Periodic Dam Safety Inspection Report

Serenity Lake Dam

September 2001
Pub. No. 01-11-014

Periodic Inspection Report

**Figure 3 - Serenity Lake Dam
Dam Crest Survey**

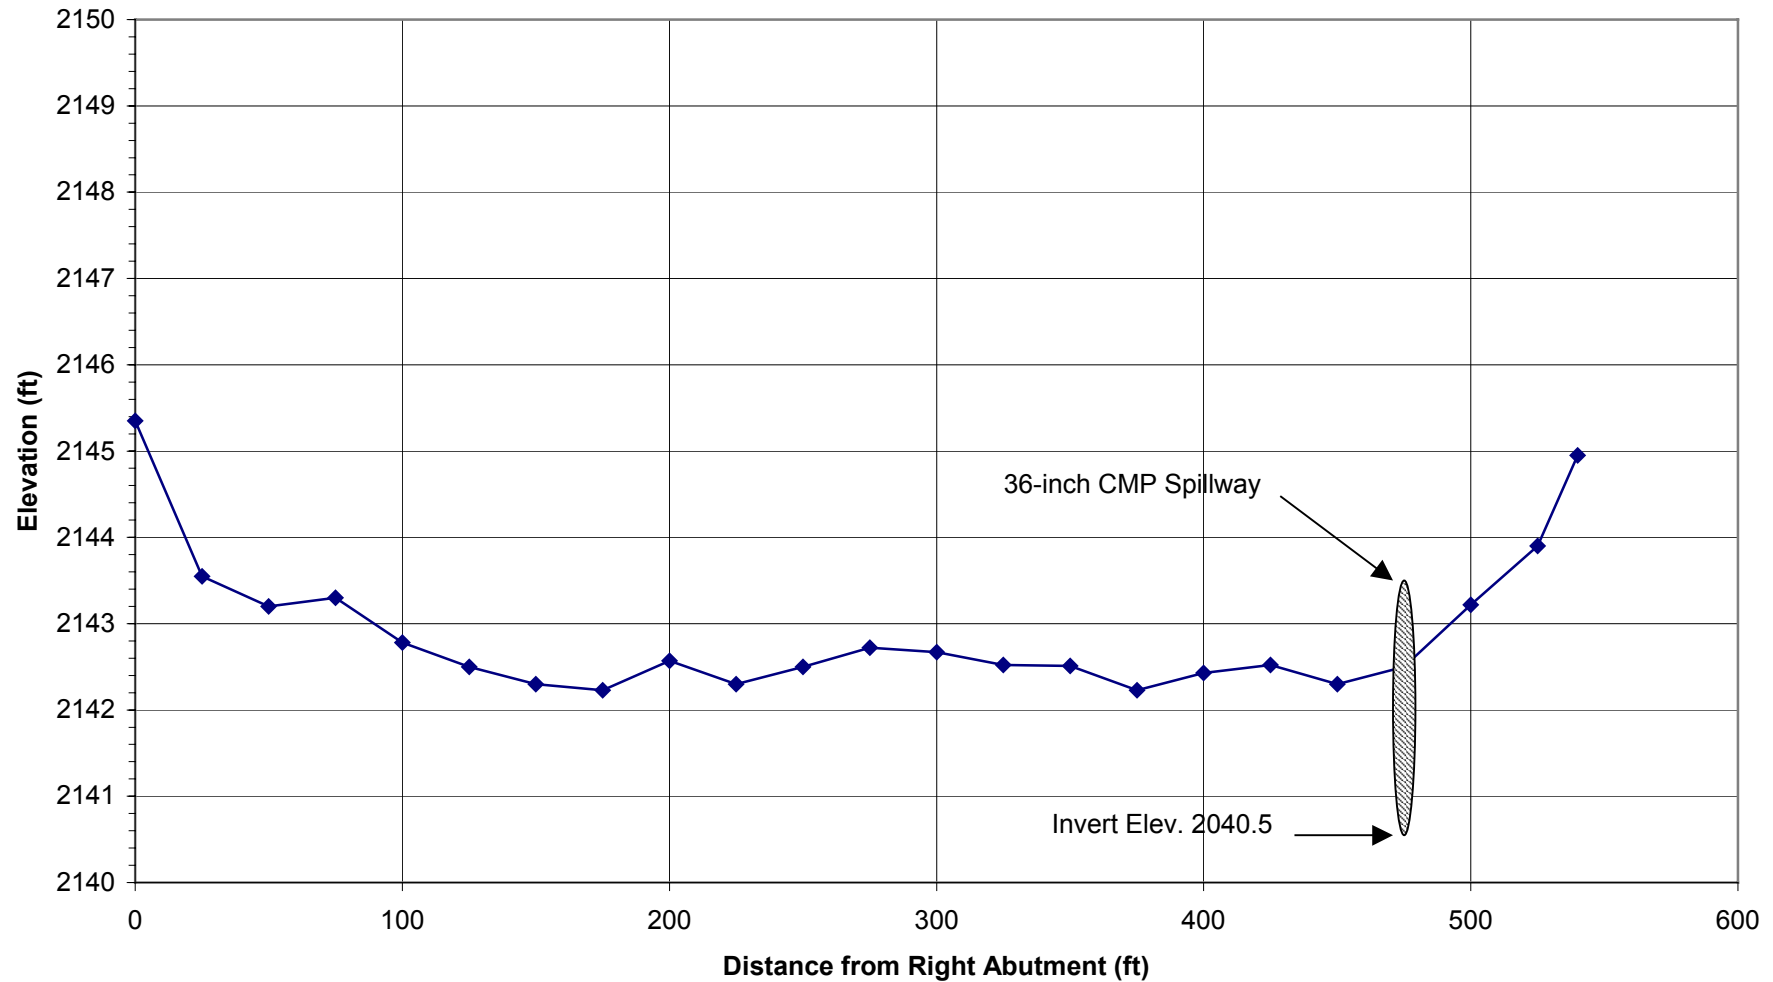
We next examined the dam crest, and discovered no cracks, sinkholes, erosion, or other signs of instability. Our survey of the dam crest showed that most of the dam crest was below the design elevation of 2143 feet. This has resulted in only 1.5 feet of freeboard instead of the 3.4 feet shown on the dam plans. Several animal burrows were noted crossing the crest, which could pass water if the pool rises to a few inches below the crest. We informed the Longs that these burrows needed to be filled in.

Figure 4 – Serenity Lake Dam Break Inundation Map
Failure during 500-year flood

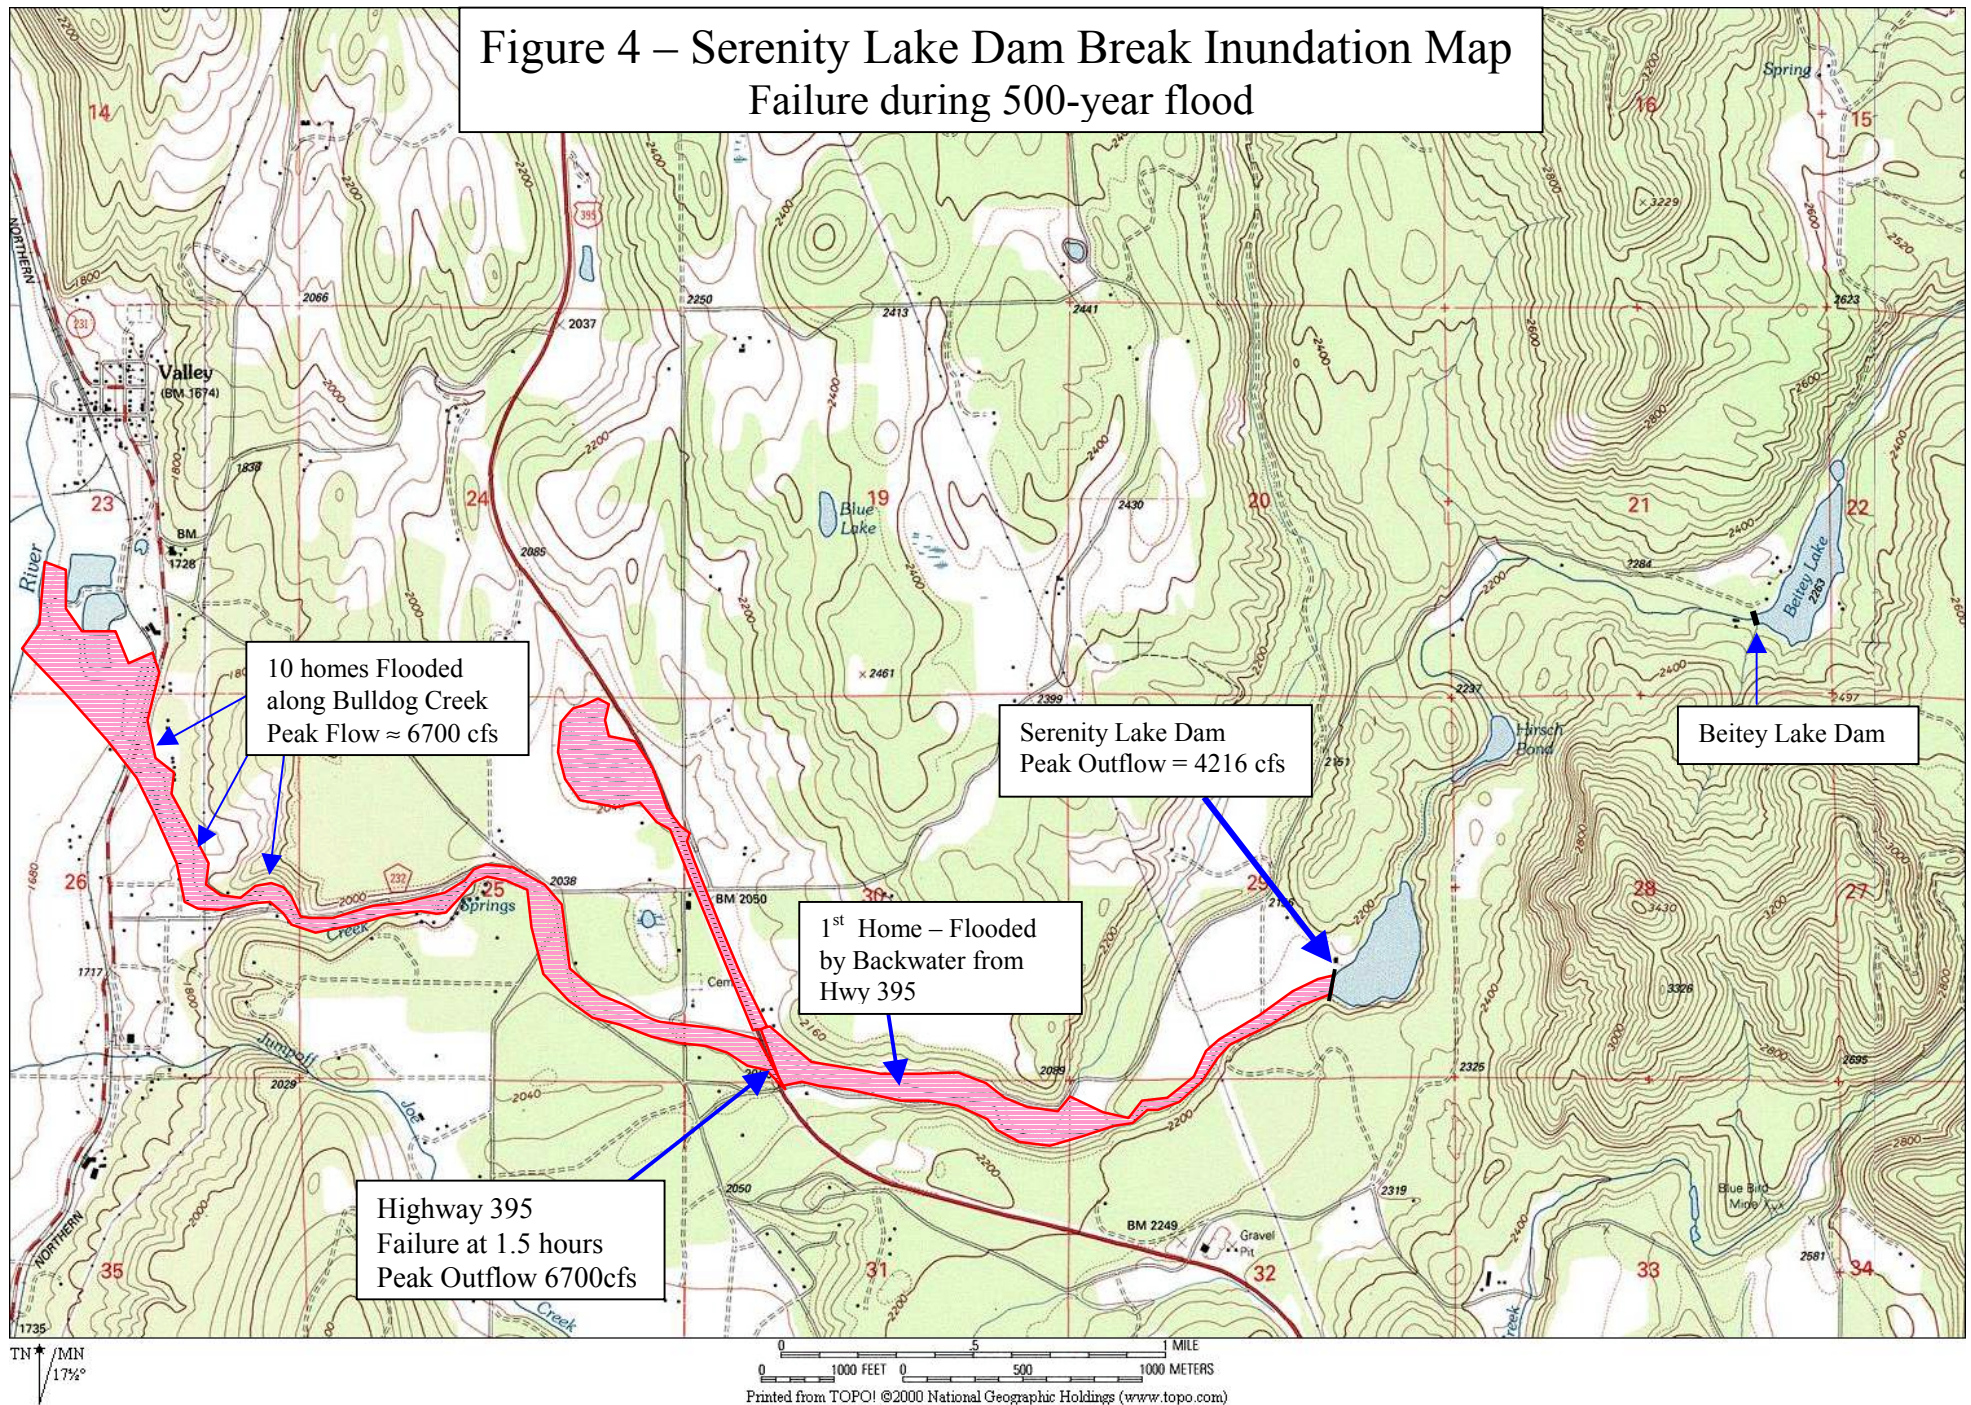
The dam break flood was then routed downstream to the US Highway 395 roadfill using the Muskingum Routing routine in the HEC-1 model. *(More detailed flood routing was not considered necessary here, as the only home in this reach would not be inundated initially by the dam break flood, but would be flooded by backwater behind the Highway 395 roadfill.)* The dam break flood was then routed through the roadfill, modeling it as a dam and reservoir. The elevation-storage capacity curve was developed using USGS topographic maps and DSO survey data. The maximum storage capacity behind the roadfill before it begins to overtop the right abutment (at Elev. 2059.0 feet) was estimated to be 350 acre-feet. Since the 500-year flood was already occurring, the limited capacity of the culvert resulted in the roadfill already being surcharged to within 4 feet of the abutment prior to arrival of the dam break flood. The dam break flood would exceed the remaining storage capacity and would overtop the right abutment by 1.3 feet. This would send most of the overtopping flow of 360 cfs down Highway 395 to the north, toward a large natural depression. However, some flow would pass over the top of the roadfill into the creek channel below. It is quite possible that the Highway 395 roadfill would fail under this loading, by piping, since the roadfill wasn't designed as an impounding barrier. If the roadfill fails, the HEC-1 model estimated the peak discharge at nearly 6,700 cfs. The detailed flood routing was not carried beyond the Highway 395 roadfill. Clearly, by inspection, a flood of this magnitude would overwhelm Bulldog Creek and destroy the 10 homes located there.

Based on these findings, a total of 11 homes are potentially at risk from a failure of Serenity Lake Dam. In addition, the dam break flood could wash out a major state highway, and cause another small dam to fail. Therefore, the hazard classification for the Serenity Lake Dam should be upgraded to **Hazard Class 1B, High** Downstream Hazard. An Inundation Map showing the property at risk is shown in Figure 4.

Figure 7
Serenity Lake Dam Repair Option 1

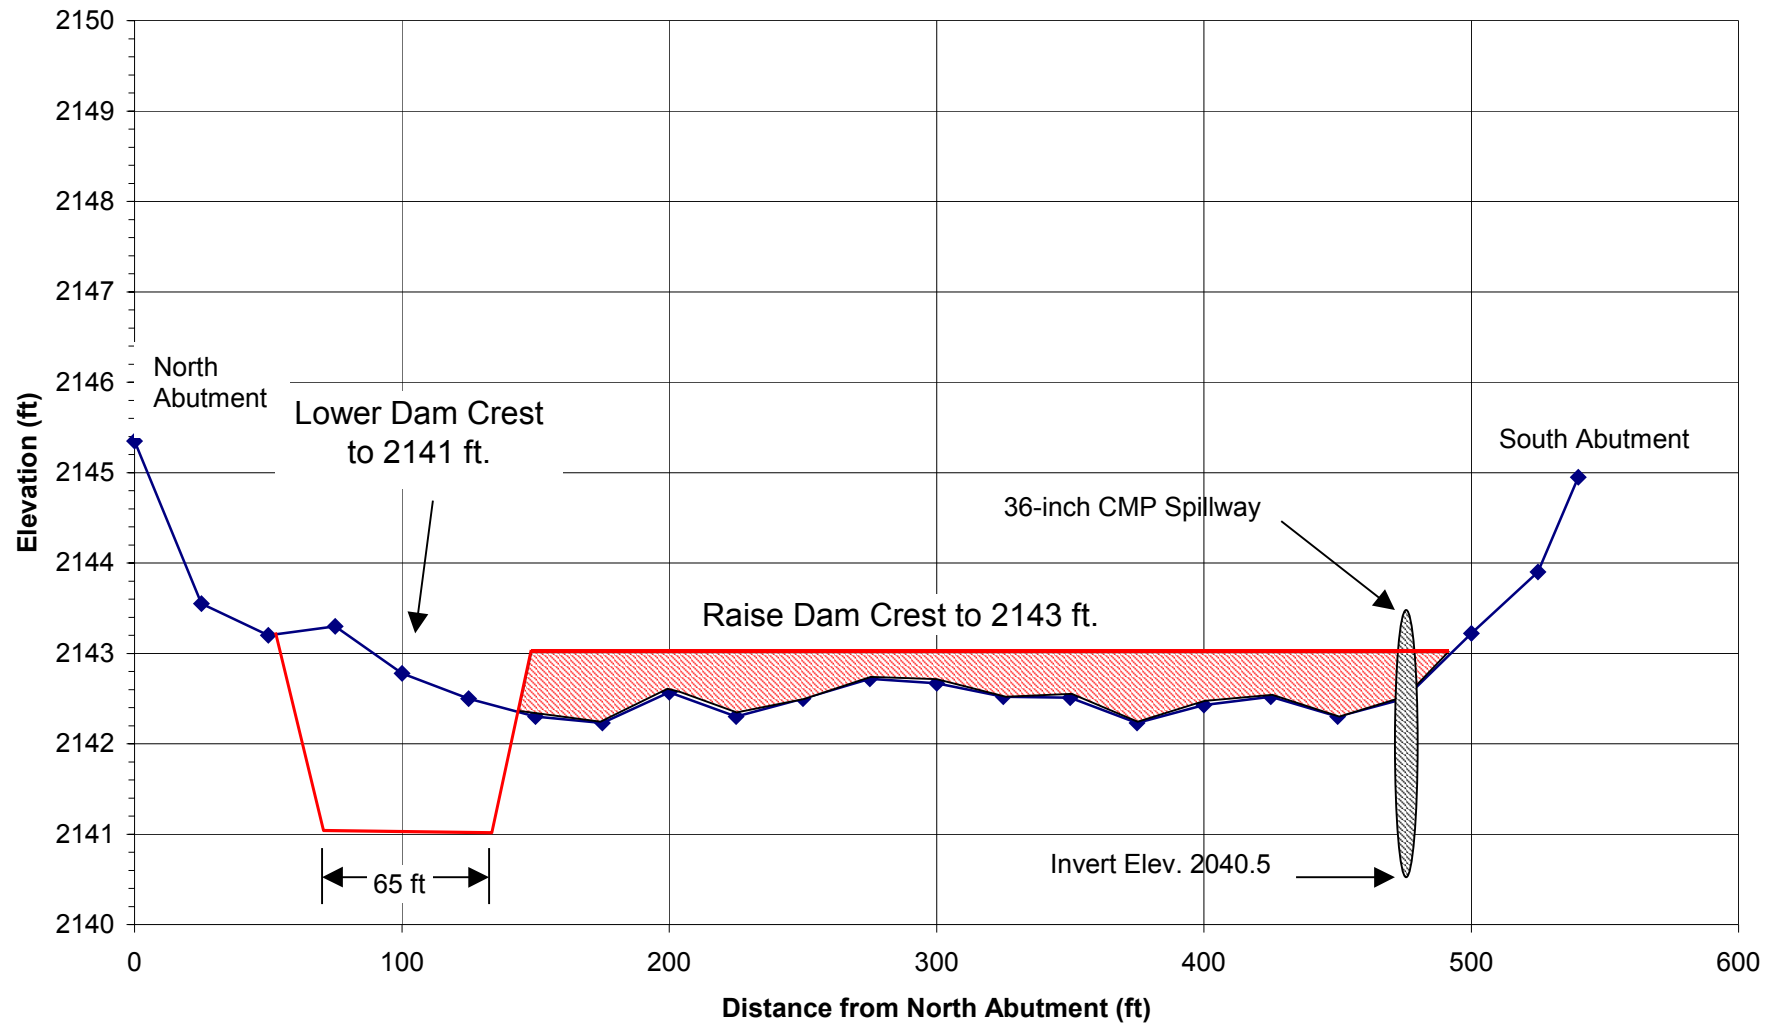
Option 1: Raise Dam 0.7 feet and add 60 foot wide emergency spillway – This option would involve adding fill to the dam to restore the crest elevation to 2143.0 feet, and lowering a 60 foot wide section of the dam near the right abutment to act as an emergency spillway. The lowered section would have an elevation of 2141.0 feet, 0.5 feet above the invert of the existing spillway pipe. Ideally, this area would be in native soil and would require only minor erosion protection. This option would allow the lake level to remain at its current elevation. Figure 7 provides a conceptual drawing of this repair scheme. With these modifications, the dam can handle the IDF with 0.3 feet of freeboard below the crest elevation. The advantage of this scheme is that it would be relatively easy and inexpensive to construct. The disadvantage is that the lake would continue impounding more water than allowed under the reservoir permit and water right certificate, and the owners would have to apply for a water rights change from the Dept. of Ecology.

As discussed previously in this report, Serenity Lake Dam does not have adequate spillway capacity for handling the Step 3 Inflow Design Flood event. In fact, the existing dam and spillway can only handle about a 5-year flood, which means there is a 20% chance of the dam being overtopped in any given year. Thus, modifications are clearly needed to increase the spillway capacity. Two possible options for the capacity increase were detailed in Section 4.2 and are summarized here:

Option 1: Raise Dam 0.7 feet and add 60 foot wide emergency spillway – This option would involve adding fill to the dam to restore the crest elevation to 2143.0 feet, and lowering a 60 foot wide section of the dam near the right abutment to act as an emergency spillway. The lowered section would have an elevation of 2141.0 feet, 0.5 feet above the invert of the existing spillway pipe. Ideally, this area would be in native soil and would require only minor erosion protection. This option would allow the lake level to remain at its current elevation. Figure 7 provides a conceptual drawing of this repair scheme.

Figure 8
Serenity Lake Dam Repair Option 2

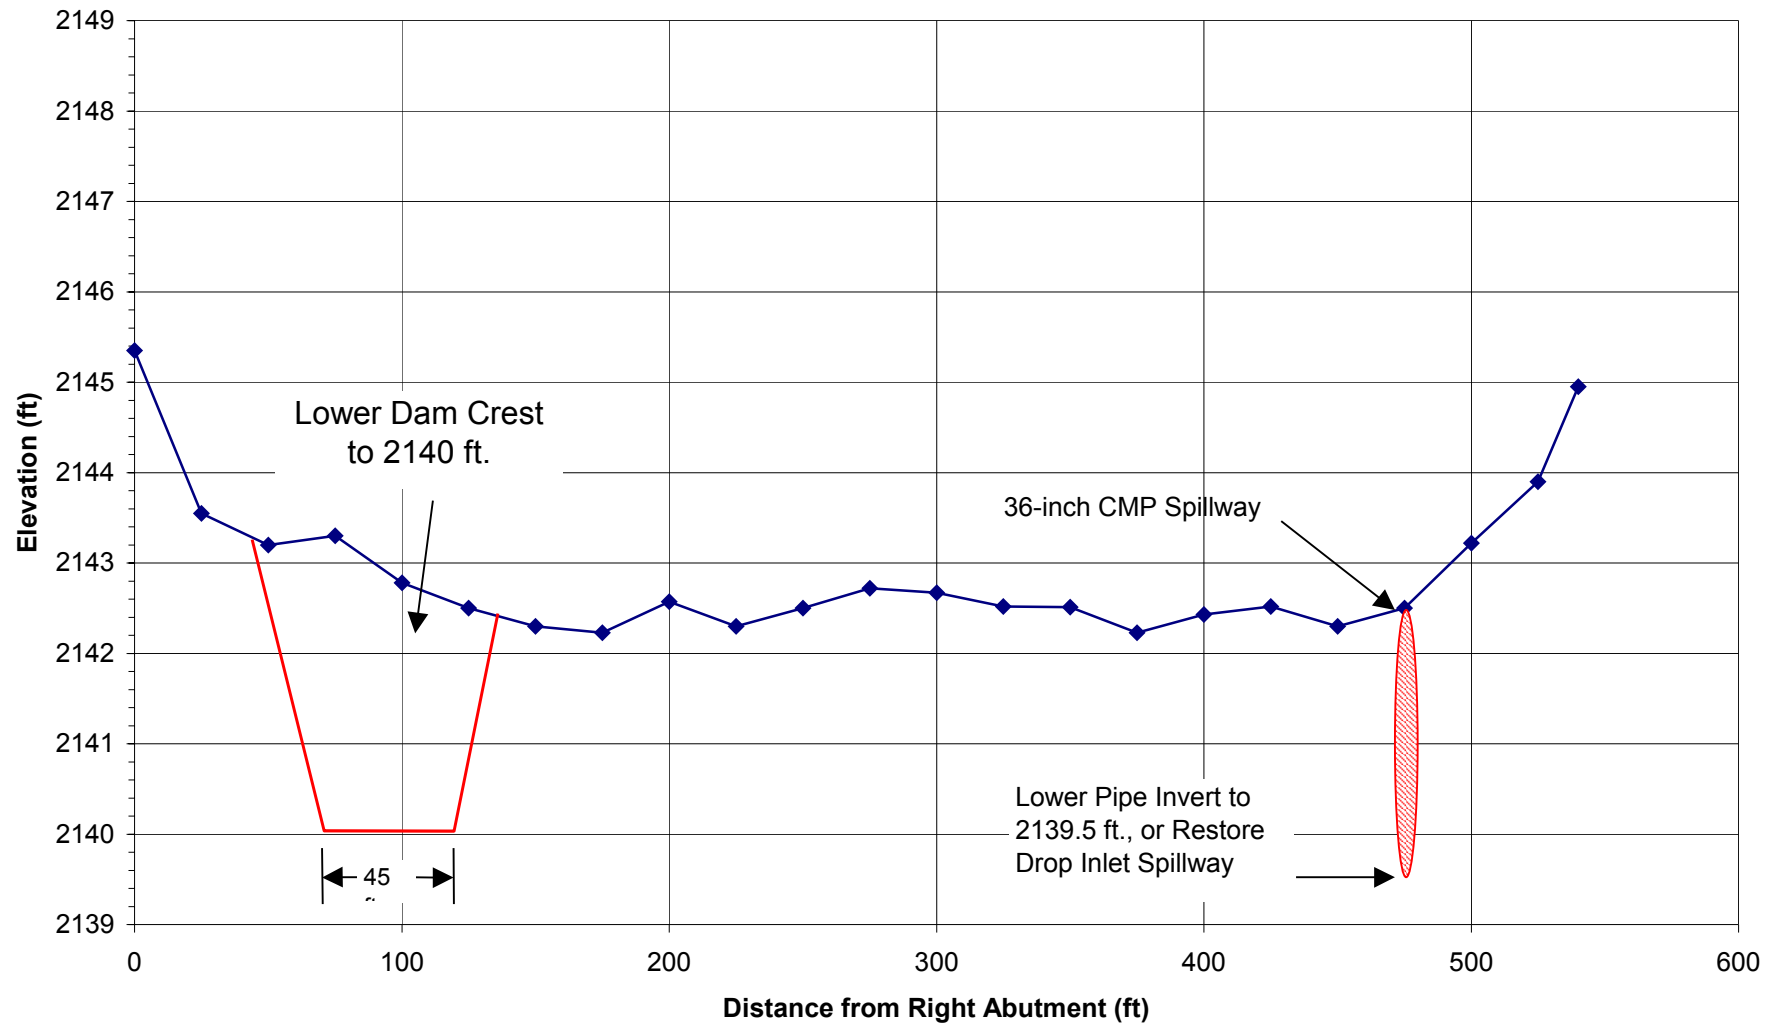
Option 2: Reduce lake level, add 45 foot wide emergency spillway – This option would involve retaining the existing dam crest elevation, restoring the drop-inlet or lowering the 36-inch CMP to maintain normal lake elevation at 2139.5 feet, and lowering a 45 foot wide section of the dam crest to 2140.0 feet to act as an emergency spillway. Under this repair scheme, the dam could pass the flood with 0.2 feet of freeboard below the crest. However, if 3 short sections of the dam crest were filled in, the freeboard would increase to 0.4 feet. The advantage of this scheme is that the dam crest would not have to be raised, and the lake storage would be restored to the permitted volume of 115 acre-feet. The disadvantage would be the cost and difficulty of repairing the drop-inlet spillway or lowering the CMP spillway conduit.

Option 2: Reduce Lake Level, add 45 foot wide emergency spillway – This option would involve retaining the existing dam crest elevation, restoring the drop-inlet or lowering the 36-inch CMP to maintain normal lake elevation at 2139.5 feet, and lowering a 45 foot wide section of the dam crest to 2140.0 feet to act as an emergency spillway. Figure 8 provides a conceptual drawing of this option.
